PLANNING BOARD AGENDA

**SEPTEMBER 13, 2021
REGULAR MEETING ~ VIRTUAL**

**VII. VARIANCE APPLICATION:
PETROSINO, STEPHEN
312 - 18TH AVENUE
BLK - 2 LOT - 10**

**Re: Completeness/Technical Review
312 18th Avenue (Petrosino)
Block 2, Lot 10
H2M Project No. LKCP 2105**

SURVEY OF LANDS
FOR
STEPHEN PETROSINO

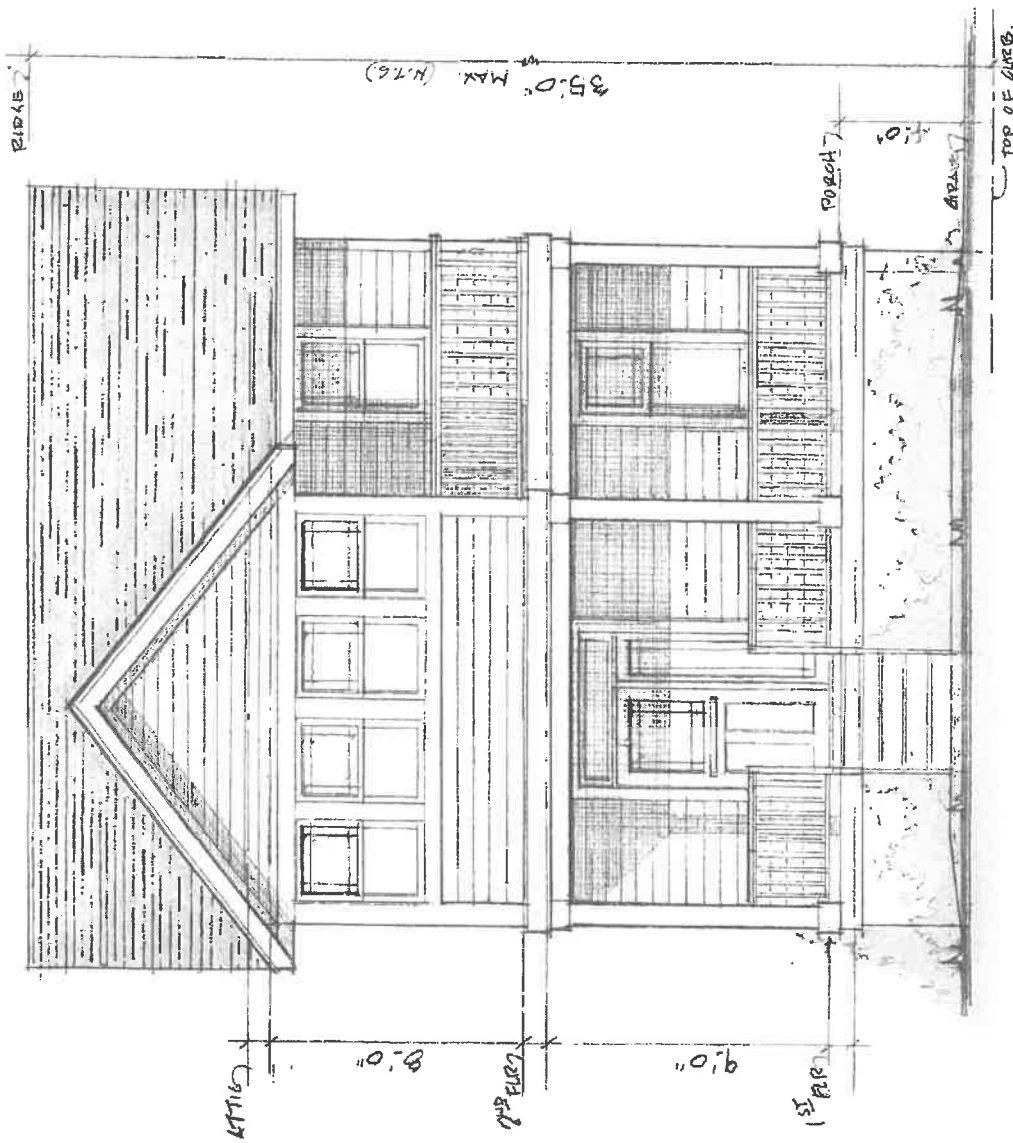
1. The first item that should be addressed by the Board is a discrepancy between the original application documents and the newly supplied survey. The Lynch survey identifies the rear structure as a frame dwelling, and my site visit confirmed that that rear structure does not appear to be a garage. The Board should elicit testimony regarding the use and floor plan of the rear structure. In the event that structure is a dwelling unit, then the multiple dwellings would be considered a non-conforming use, and the proposed addition would be an expansion of a non-conforming use (d(2)). If it is not a dwelling unit, then the Board should consider conditions such that such a structure could not be converted to a dwelling unit.

00 EXISTING PLOT PLAN 00
1" = 10'-0"

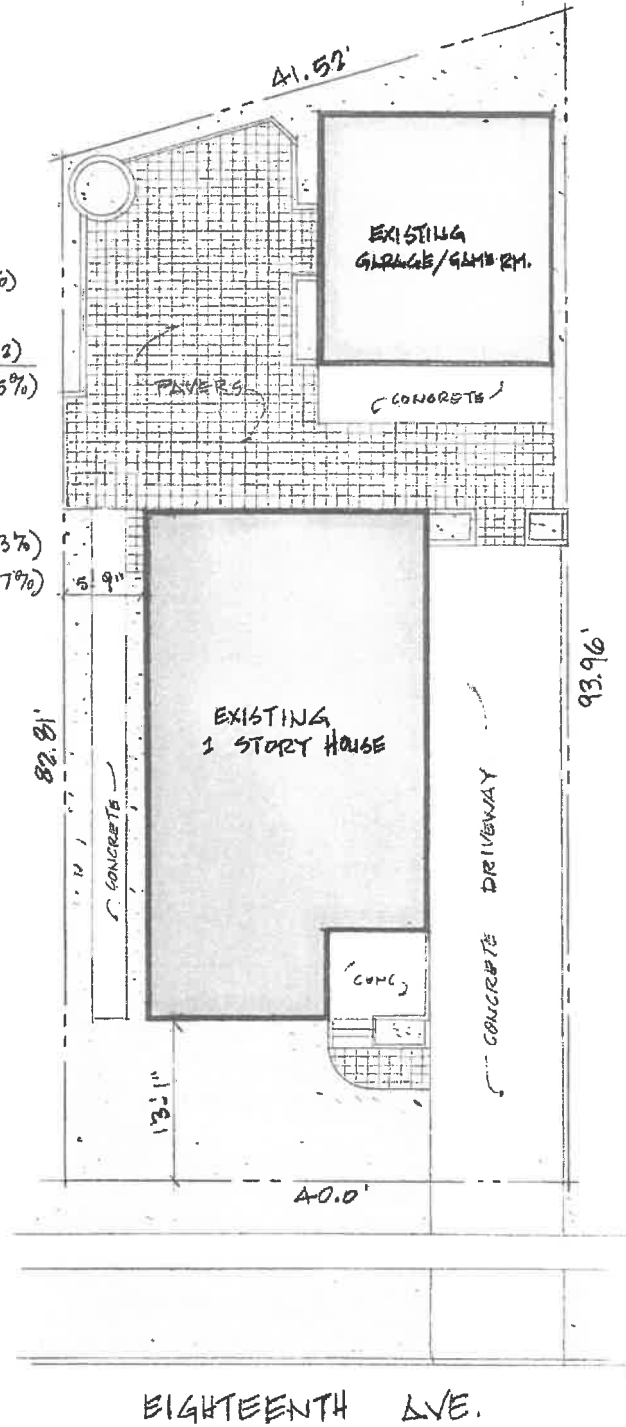
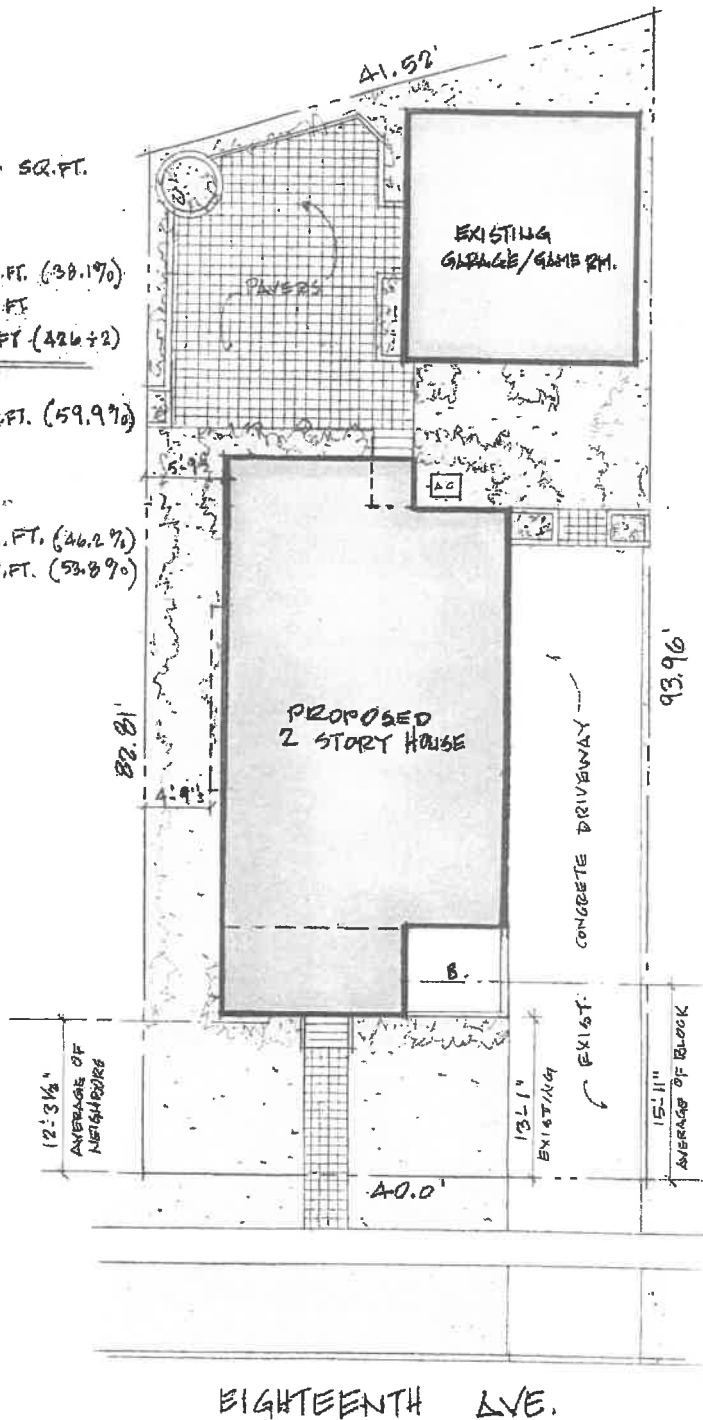
It should be noted that the Architectural plans identify the rear structure as a "garage", and the presence of a garage on a non-conforming lot matters with regard to allowable Building Coverage (35% vs. 40%). However, I do not believe the rear structure qualifies as a garage given the limits on access for vehicular parking. The Board should elicit testimony regarding this issue to determine if variance relief is required in this case.

Also, I don't understand the impervious coverage representations on the plan set. The schedule identifies an existing condition of 68.5% impervious (where 60% is the maximum allowable), and a proposed impervious cover condition of 59.9%, yet it is not clear what is changing to create the conforming condition. The Board should elicit testimony regarding this issue as well as the type and construction detail of the pavers to ensure these items qualify for the impervious reduction the Applicant is applying.
